DEVELOPMENT REVIEW BOARD REPORT

CASE NUMBER/ **102-DR-2004**
PROJECT NAME **City of Scottsdale Arsenic Mitigation Ste 115**
LOCATION **21790 N Hayden Rd**

REQUEST Request site plan and elevation approval for an arsenic treatment facility.

SITE 115 PROCESS BUILDING NORTH AND SOUTH ELEVATIONS

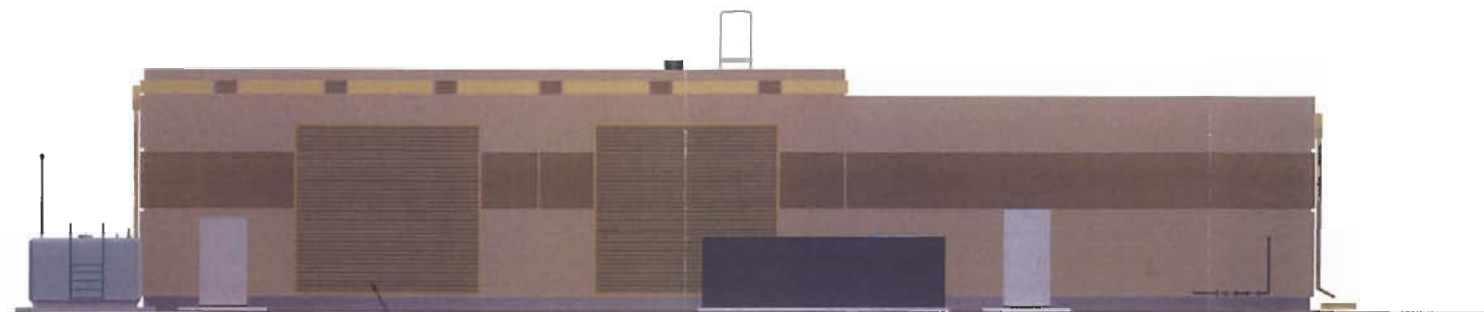
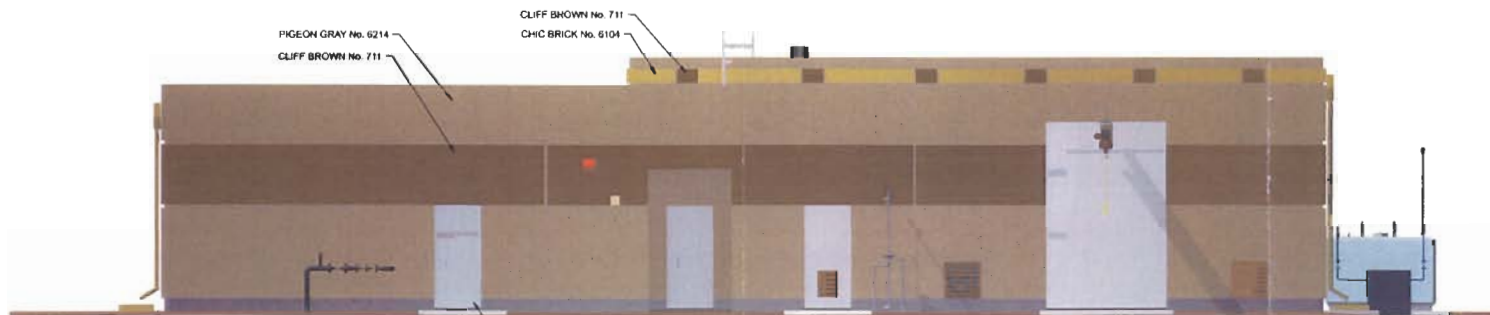
The treatment facility building colors consist of three colors, a gray field with a lower flesh tone horizontal stripe accent and an upper brick horizontal stripe accent. The doors are white. Stipulations are included to require no exposed ladders and downspouts.

1. Architectural elements, including dimensions, materials, form, color, and texture, shall be constructed to be consistent with the building elevations submitted by CH2MHill with a City of Scottsdale received date of November 2, 2004 except that no exterior roof ladder shall be allowed where they are visible to the public or from an off-site location and all roof drainage systems shall be interior.
2. The location and configuration of all site improvements shall be constructed to be consistent with the site plan submitted by CH2MHill with a design date of October 20, 2004.
3. Landscaping, including quantity, size, and location of materials shall be installed to be consistent with the conceptual landscape plan sheets L-1 through L-12 submitted by CH2MHill with a design date of October 18, 2004.
